**MONTGOMERY COUNTY HISTORIC PRESERVATION COMMISSION**  
**STAFF REPORT**

<b>Address:</b>	10212 Montgomery Ave., Kensington	<b>Meeting Date:</b>	6/14/2023
<b>Resource:</b>	Primary One Resource <b>Kensington Historic District</b>	<b>Report Date:</b>	6/7/2023
<b>Applicant:</b>	Warner Circle Mansion Condominiums, LLC (Karl Voglmayr, Agent)	<b>Public Notice:</b>	5/31/2023
<b>Review:</b>	HAWP	<b>Tax Credit:</b>	partial
<b>Permit No.:</b>	1032588	<b>Staff:</b>	Dan Bruechert
<b>PROPOSAL:</b>	Comprehensive Rehabilitation, Partial Demolition, Sitework, and New Construction

*Figure 6: Proposed house floor plan with the proposed addition outlined in red.*

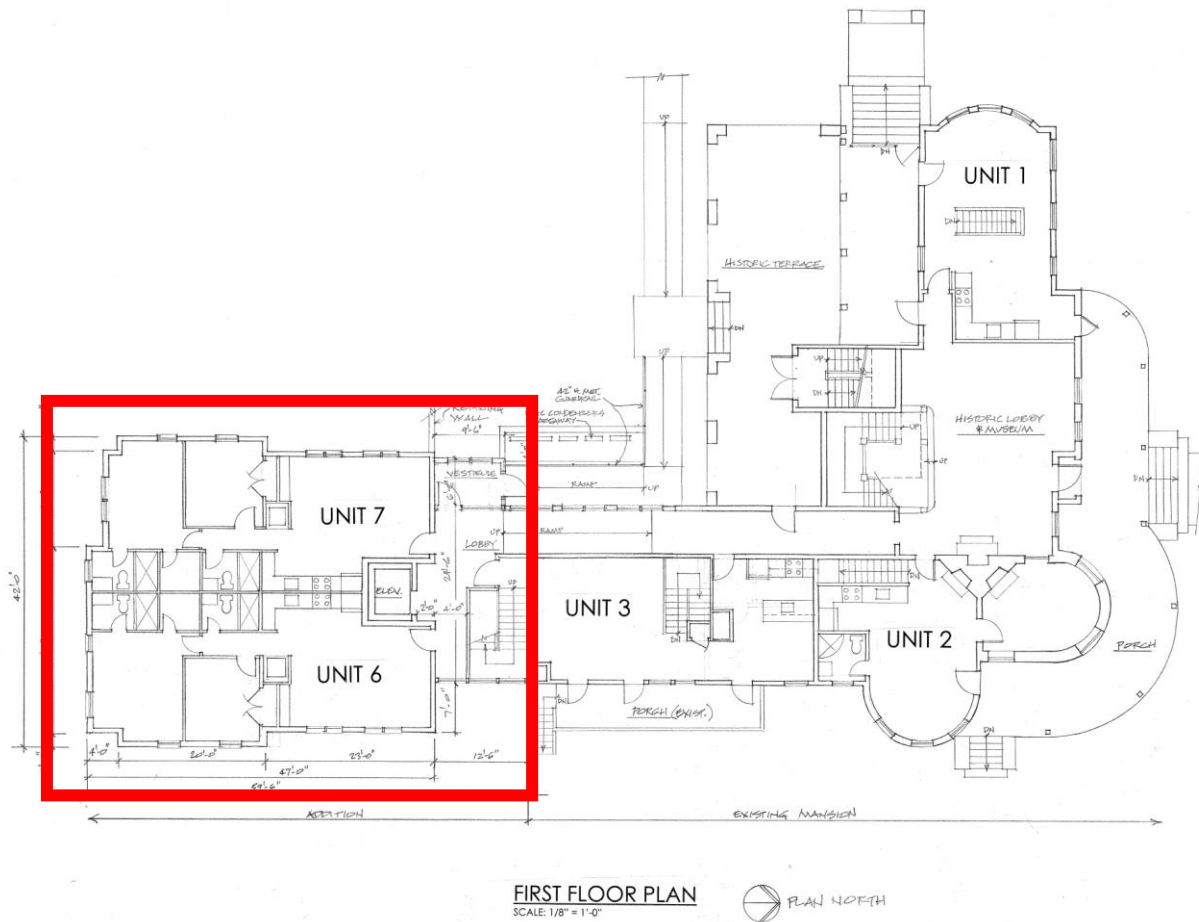
Materials proposed for the addition include fiber cement clapboards and shingles, composite trim, slate roof, clad wood windows, and wood doors. The hyphen roof, which is not visible from any public vantage point, is a membrane roof. Staff finds these materials – with one exception – are compatible with the character of the house and surrounding district. Because of their narrow profile (only ¼"), Staff does not find the proposed Hardie shakes are a compatible substitute for wood shakes. Staff recommends the HPC add a condition to the approval of this HAWP that the approval does not extend to the Hardie shakes and that either a thicker fiber cement shake with a minimum 1/2" (one-half inch) thickness or wood shakes need to be installed on the building addition with final approval authority delegated to Staff.

Staff recommends the HPC approve the addition under 24A-8(b)(2) with the added condition that the proposed fiber cement shakes are too thin to be an appropriate replacement and a thicker fiber cement shake or wood shakes need to be used.

2. The proposed Hardie shakes in the building addition are too thin to be an appropriate substitute material. A thicker fiber cement shake or wood shake shall be installed with at least a ½” reveal;

SHEET NUMBER: <b>A104</b>	REVISIONS:	DATE: 3-31-23
	WARNER MANSION CARRIAGE HOUSE RENOVATION 10226 MONTGOMERY AVENUE, KENSINGTON, MD 20895 MORRIS ARCHITECTS 13320 TRAVILAH ROAD / NORTH POTOMAC, MD 20878 TEL: 301-927-1002 morrisarc@aol.com	
PROJECT NUMBER: 2218	CARRIAGE HOUSE PLANS & ELEVATIONS

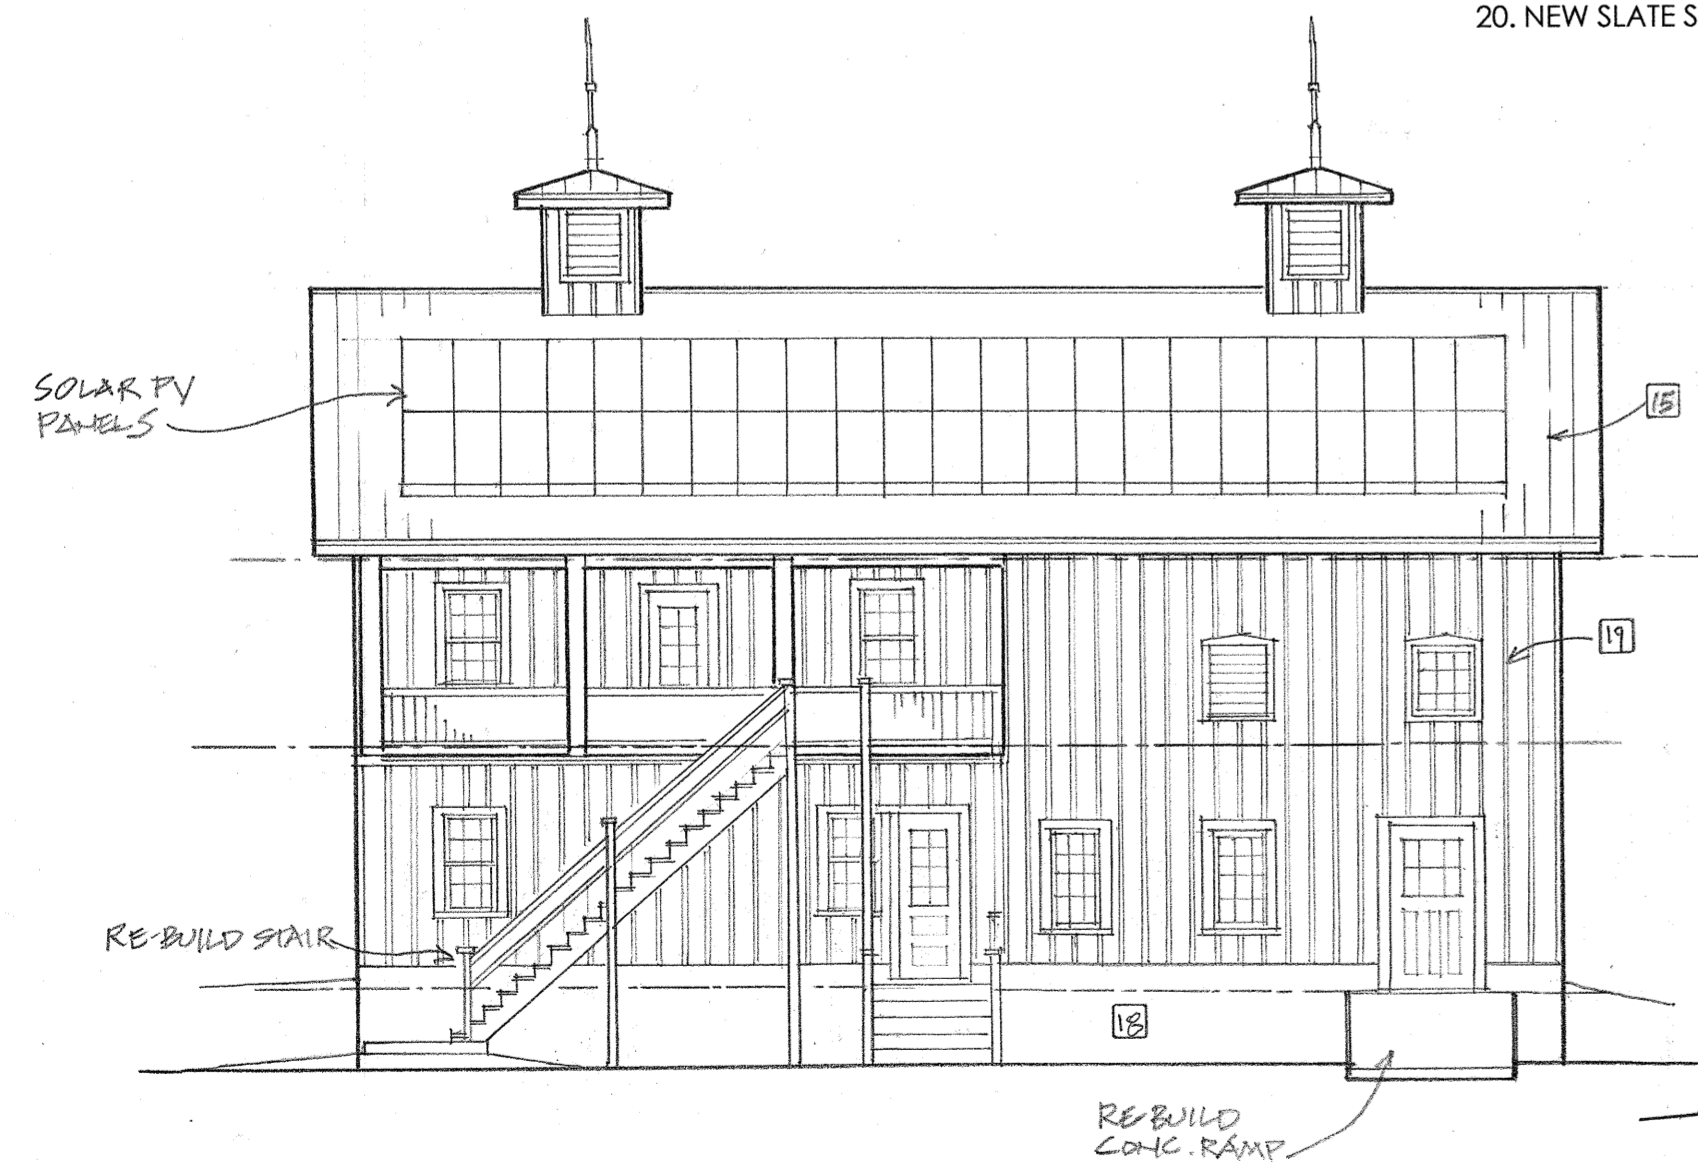
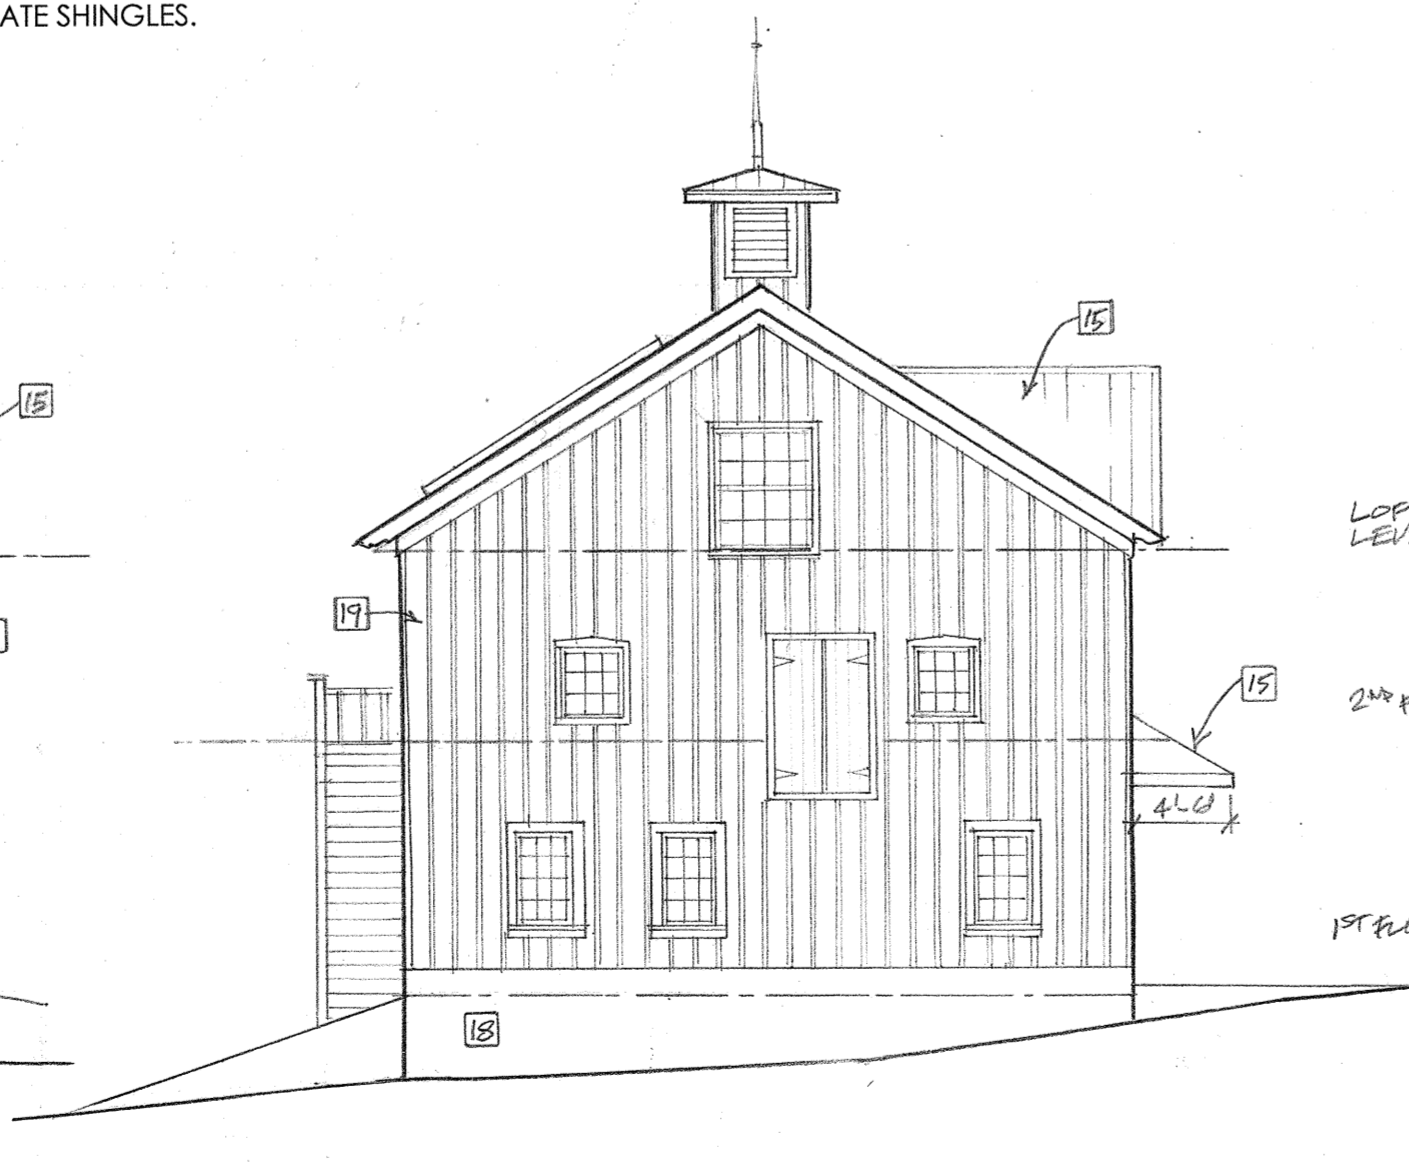
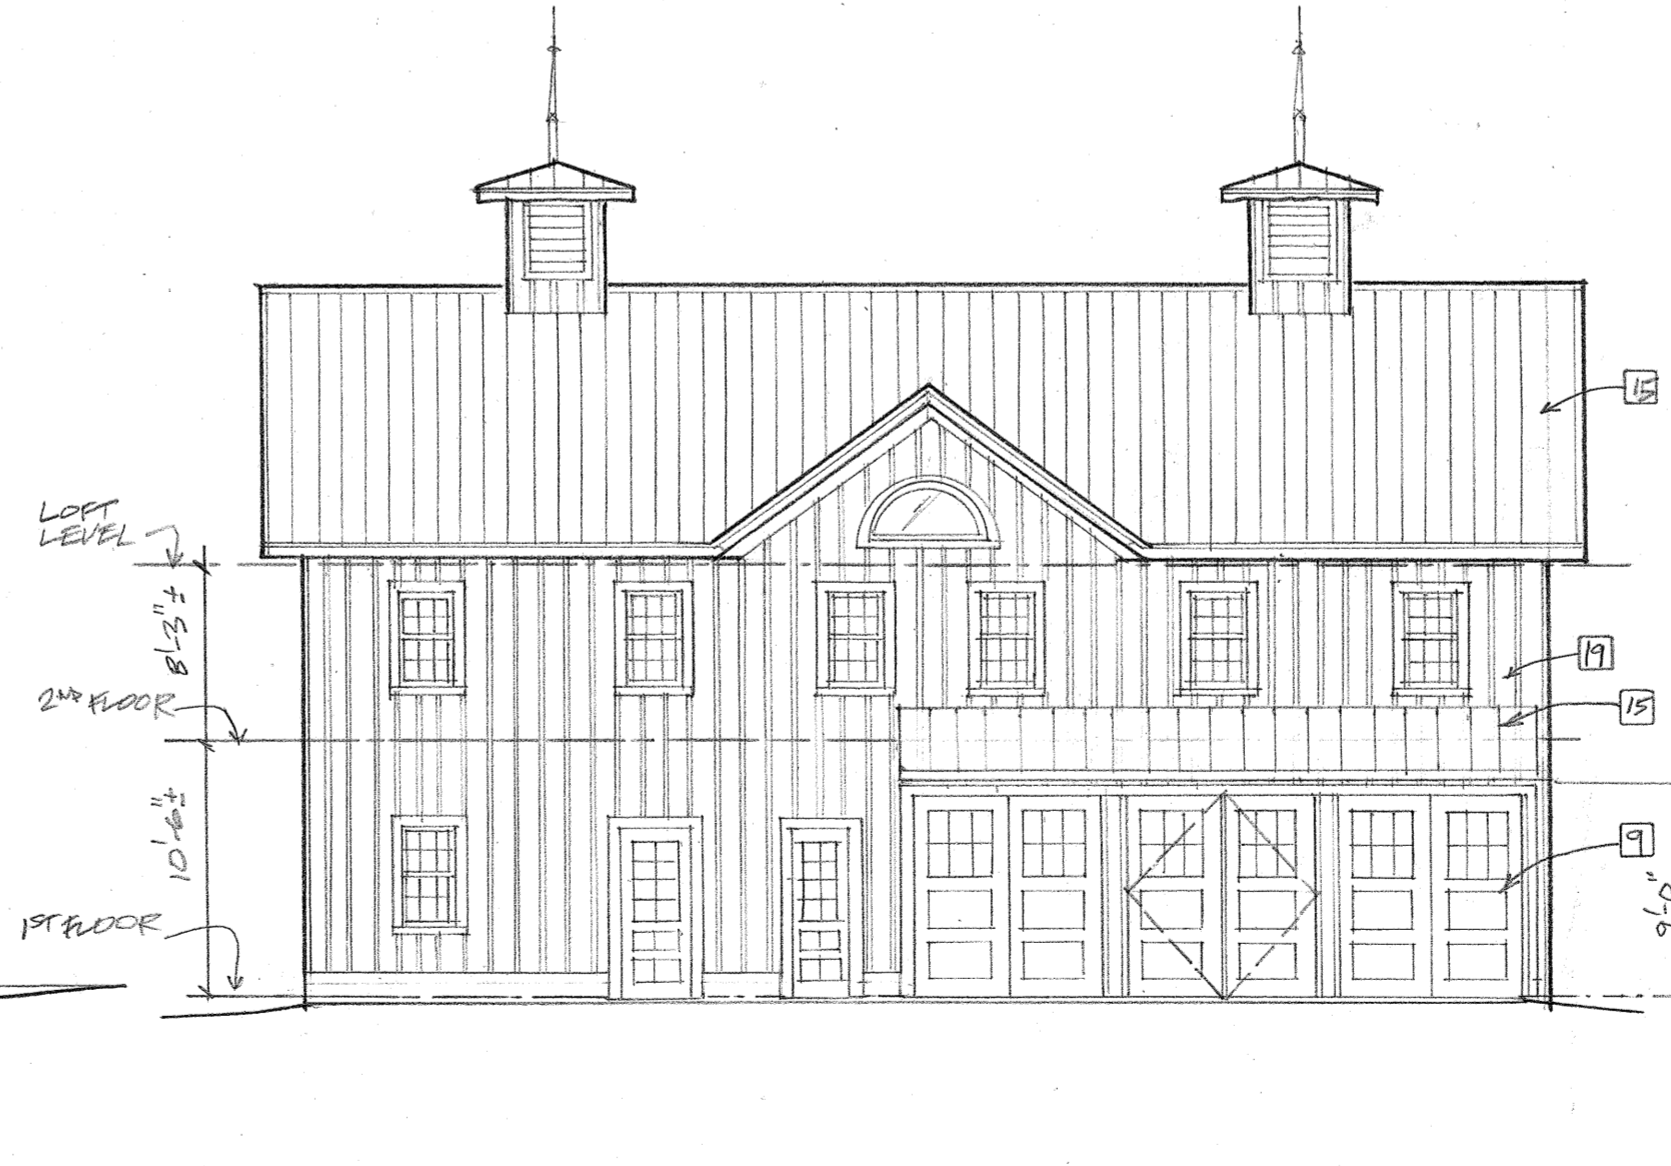
4. The proposed replacement Box Batten roofing system is not compatible with the character of the carriage house’s historic standing seam metal roof. A traditionally assembled or compatible standing seam metal roof system shall be submitted with the final permit drawings; and,

5. The railing design for the exterior rear stairs of the carriage house was not included in the submitted materials. A compatibly designed wood railing shall be submitted with the final permit drawings.

8. Staff finds removing the wood board and batten siding on the carriage house and replacing it with fiber cement siding inappropriate. Revised permit drawings shall show repaired or replaced wood board and batten siding for the carriage house cladding. Final approval authority to verify the condition has been satisfied is delegated to Staff.

**CARRIAGE HOUSE NORTH ELEVATION**  
SCALE: 1/8" = 1'-0"

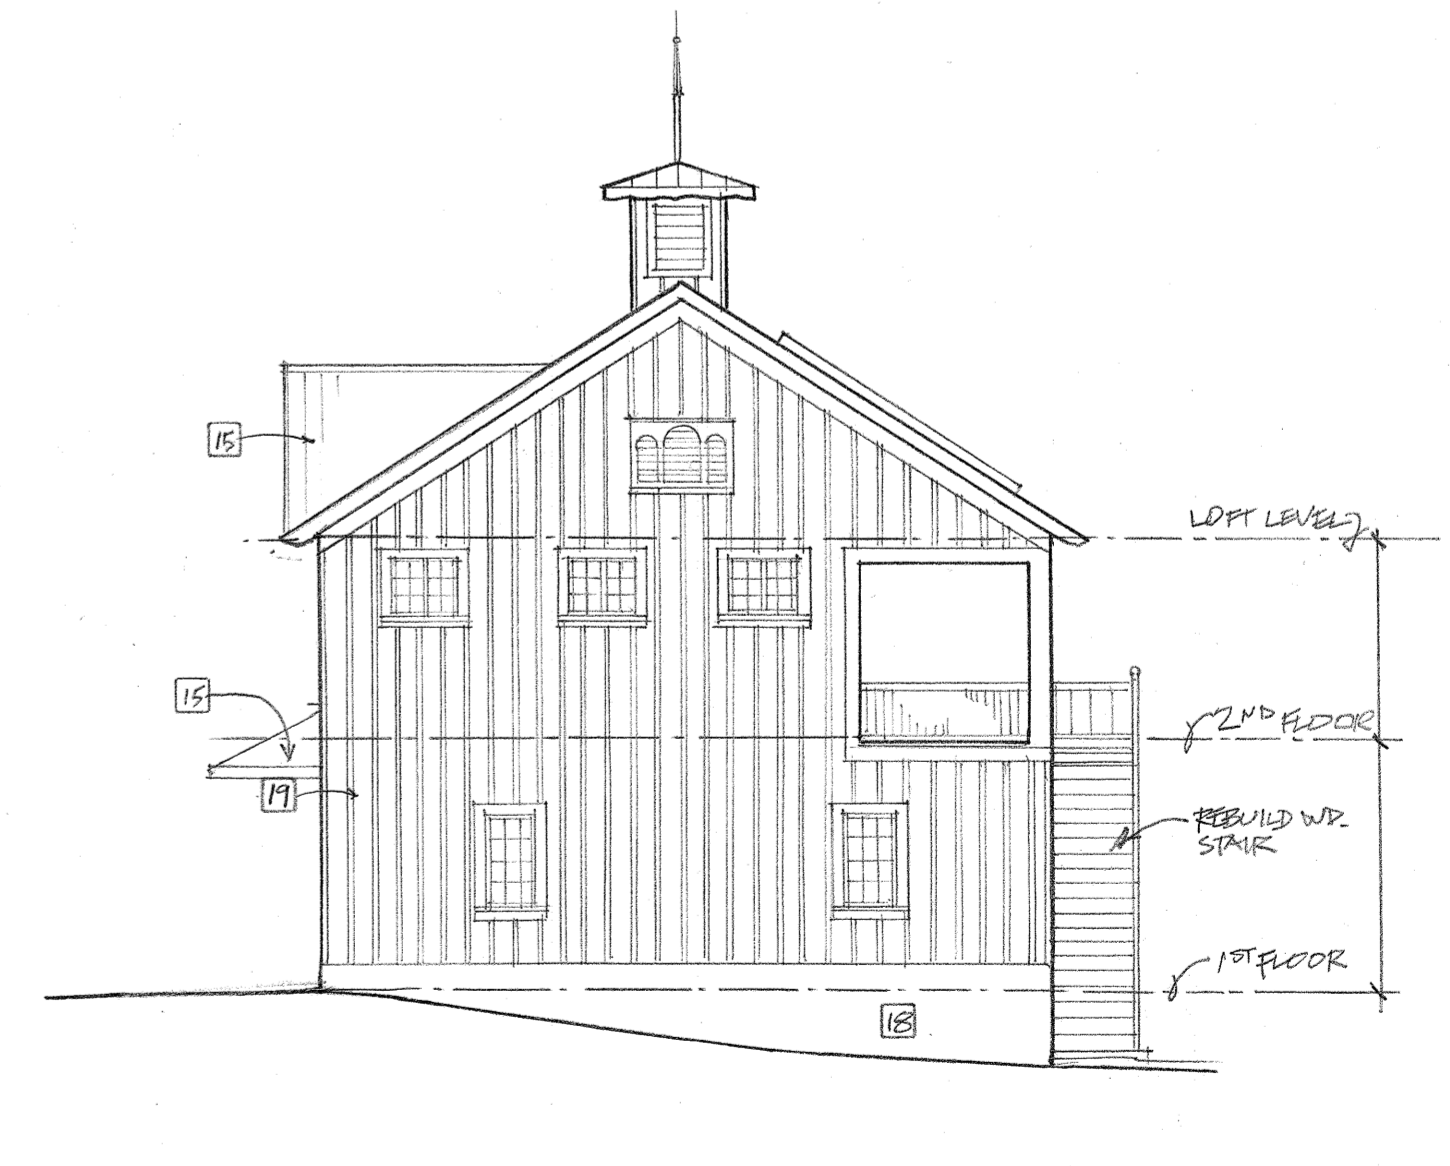
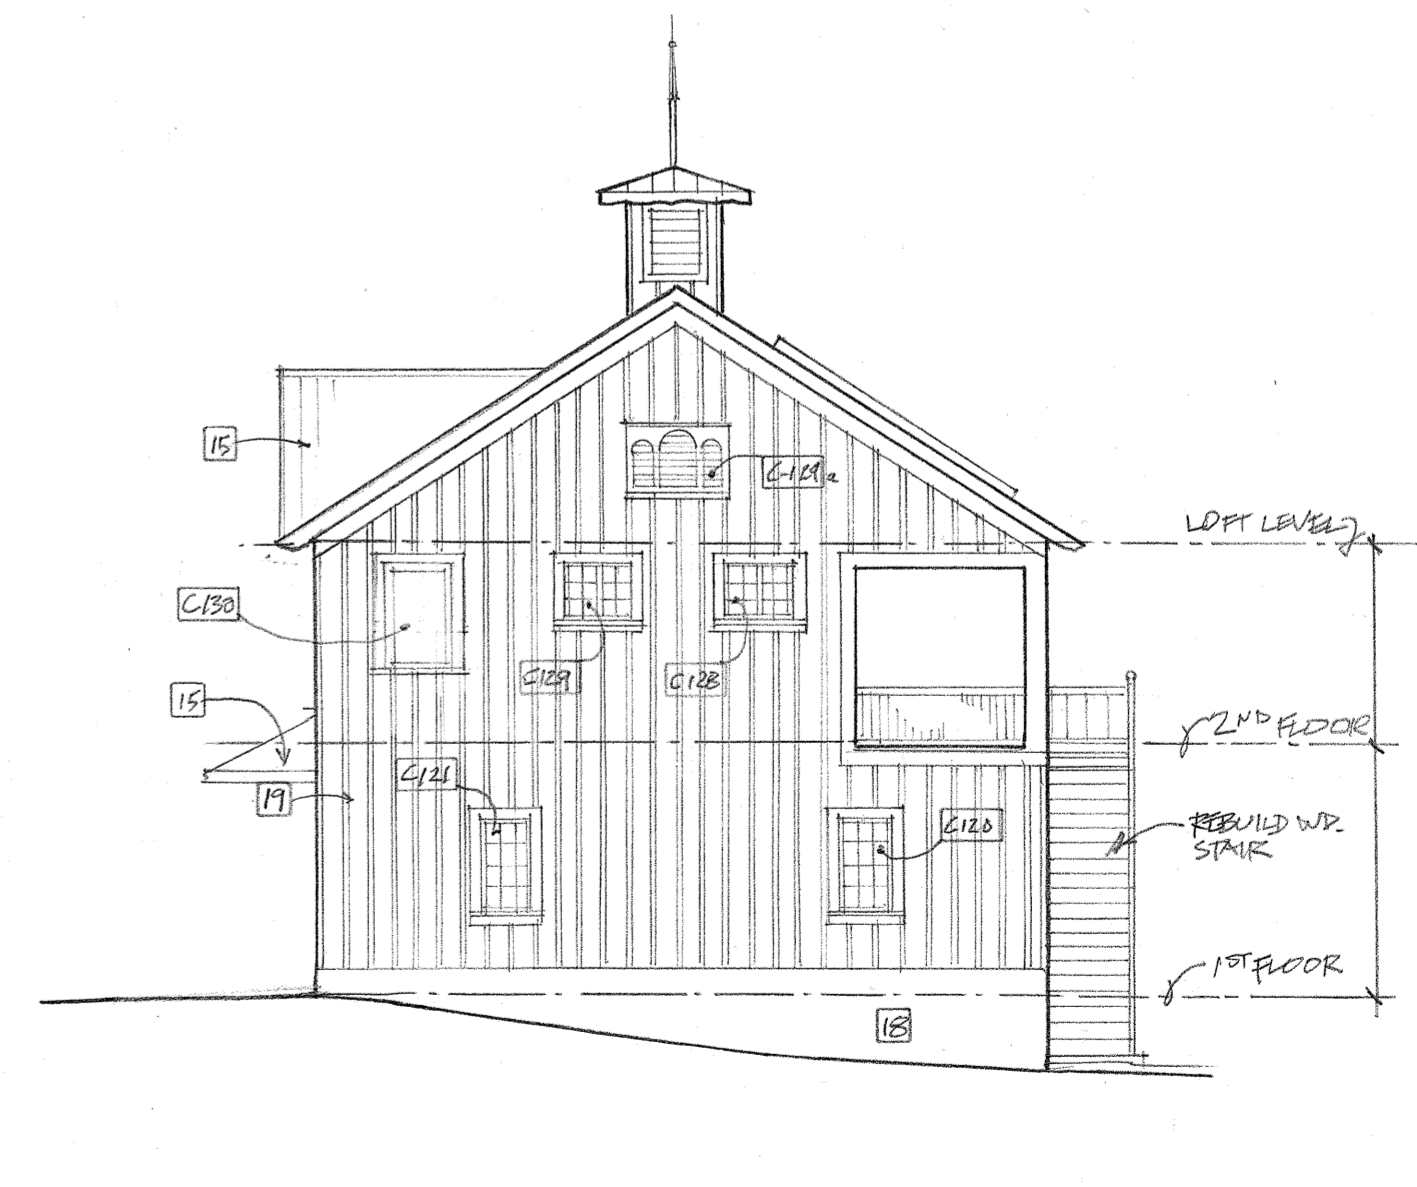
3. The half-round louver in the north-facing gable on the carriage house shall not be replaced with a single-lite window. Revised drawings showing the retention of this louver shall be submitted with the final permit drawings;
